## ENGINE IDLE & FUEL VAPOR IN CESSNA 172R / 172S

### A Historical Compilation of Service Publications

Airworthiness Concern Letter

Figure 3. Fuel Return to Reservoir Installation (Sheet 1)

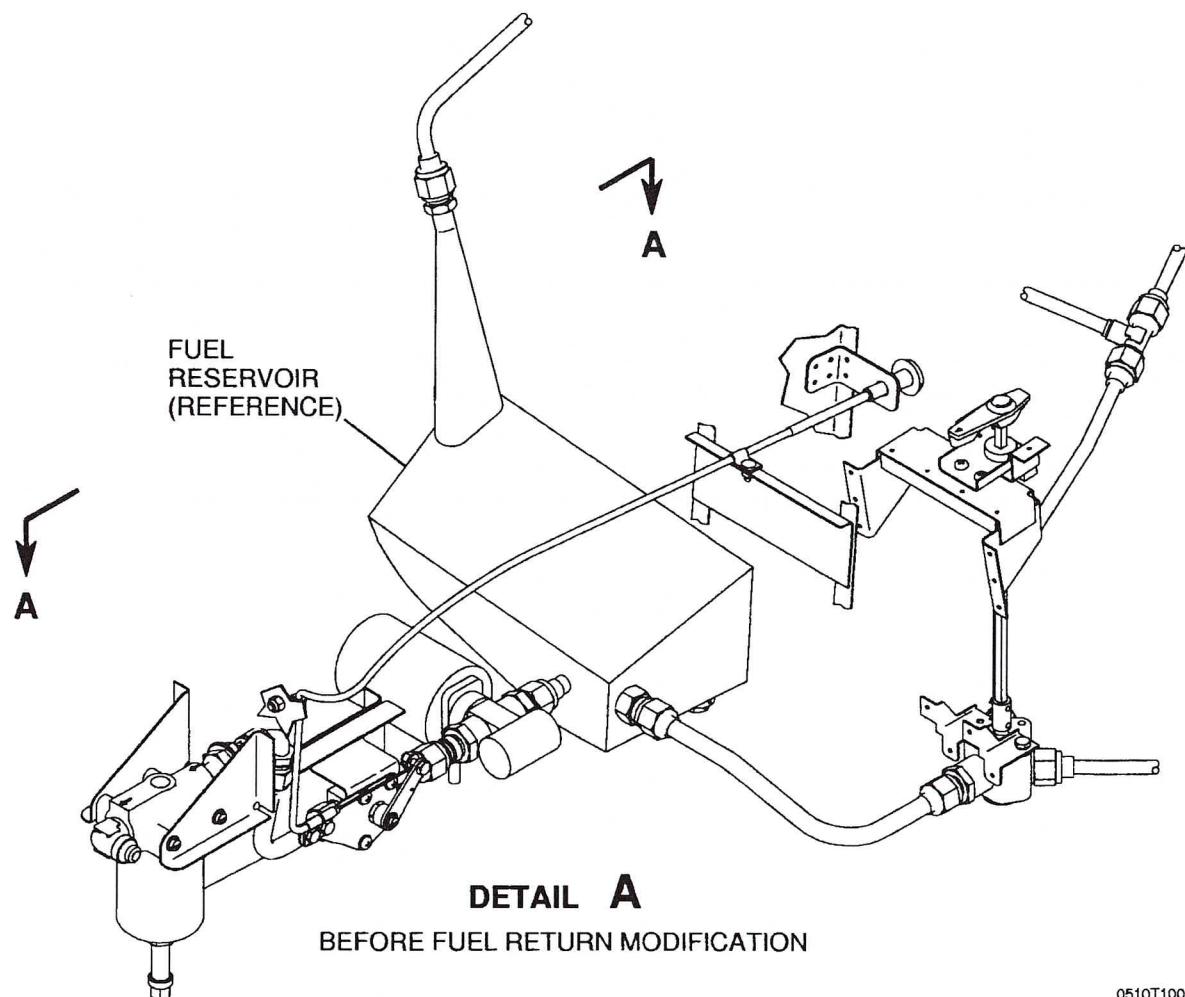
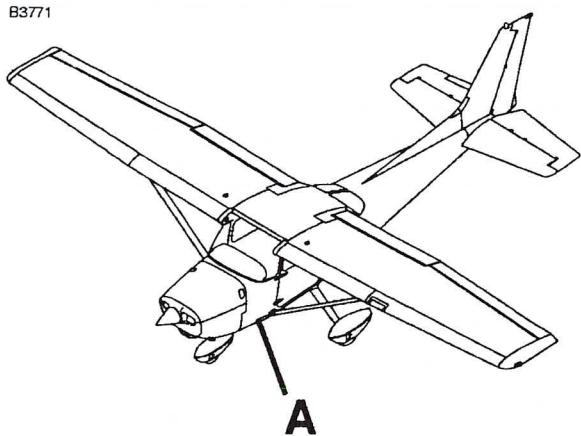
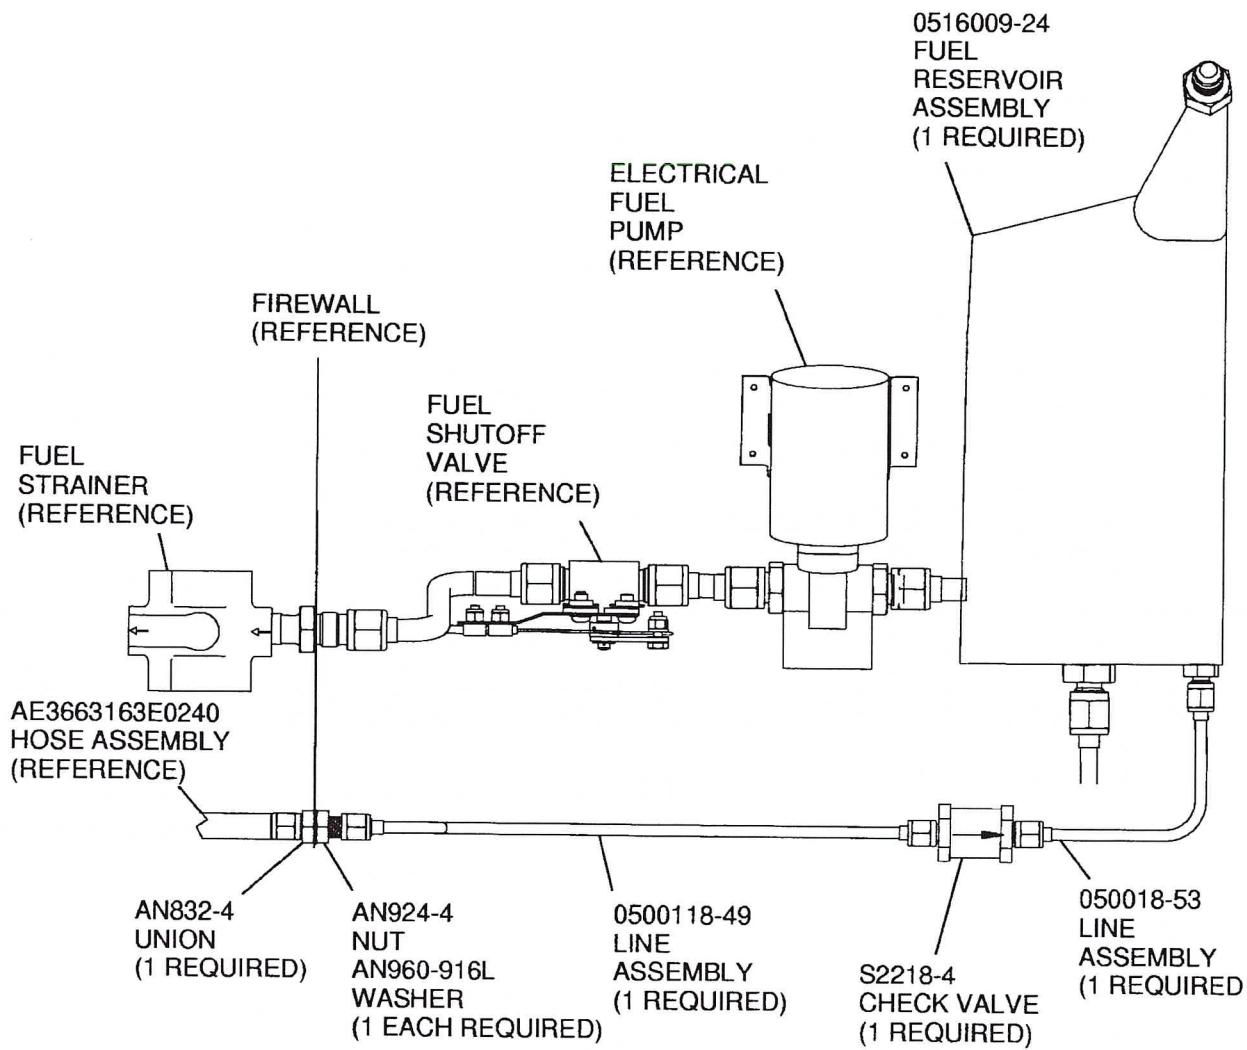
11. (Refer to Figure 3, Sheet 1.) Install the 0500118-49 Line Assembly from the aft side of the firewall AN832-4 Union to the S2218-4 Check Valve. Install the S2218-4 Check Valve and make sure the check valve flow arrow points to the reservoir.

14. Install a new 0500118-53 Line Assembly from the aft end of the S2218-4 Check Valve to the new 0516009-24 Fuel Reservoir Assembly. (Refer to the Model 172 Series 1996 and On Maintenance Manual, Chapter 28, Storage and Distribution- Maintenance Practices.)
15. Fuel the airplane and do a fuel leak inspection.
16. Install the floorboards and the side panels removed in Step 6.

Figure 1.

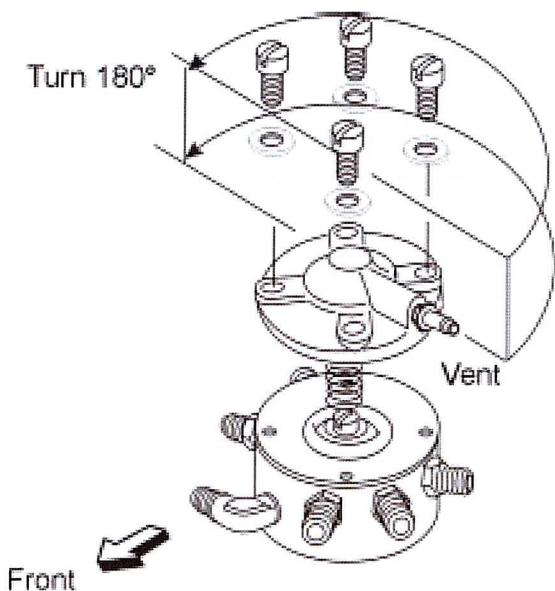
- a. Remove the lockwire, screws and washers from the top of the flow divider assembly. (Figure 1.)
- b. With the cap vent pointing left, slightly lift the manifold cap, making sure that it is separated from the diaphragm. Then carefully rotate it until cap vent points right. (180° from original position.) (Figure 1.) Be sure that the spring held in place by the cap is not dislodged.

Figure 2.

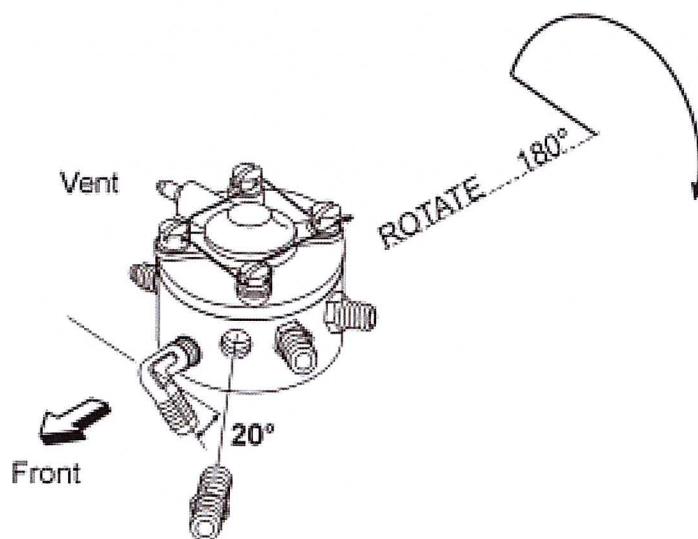
- d. To allow removal and installation of the 90° fuel inlet elbow, first remove the fuel gage fitting close to the elbow on the forward side of the flow divider. (Figure 2.)

- e. Holding the flow divider with the manifold cap up, remove the 90° elbow P/N MS20822-4 and install the new 90° elbow with the elbow positioned below the gage fitting port pointed left and tilted approximately 20° below horizontal. Reinstall gage nipple. The angle allows clearance for hose connections. Before reinstalling the fittings, apply Loctite Hydraulic Sealant or an equivalent fuel soluble sealant sparingly. Do not apply sealant to the first two lead threads. (Figure 2.)
